Intel[®] 865G/865GV Chipset

Specification Update

Intel[®] 82865G/82865GV Graphics Memory Controller Hub (GMCH)

Document Number: 252515-003

1. Package Dimensions (Bottom View)

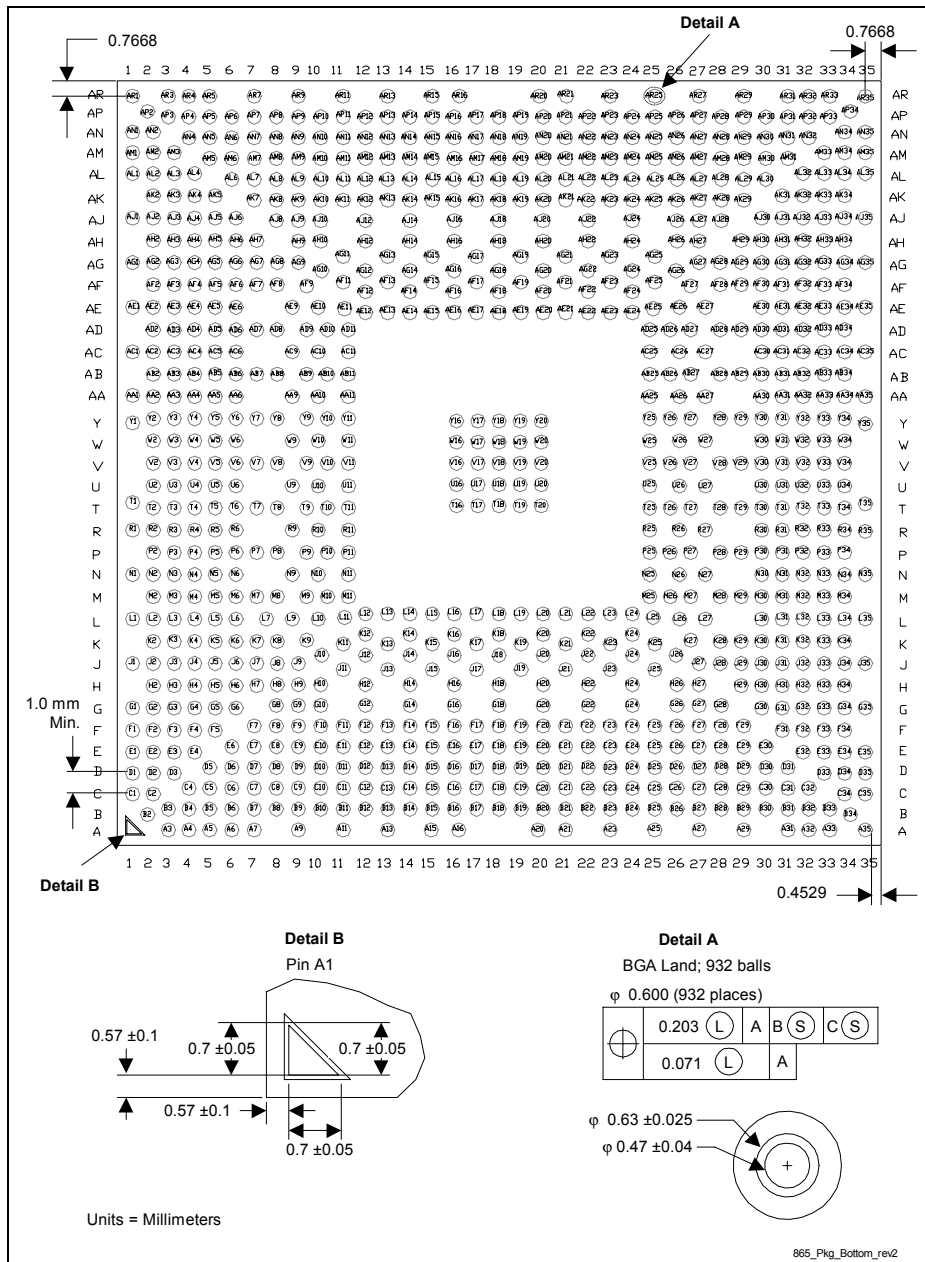
Figure 19, “Intel® 82865G GMCH Package Dimensions (Bottom View)” is replaced with the following, corrected figure:
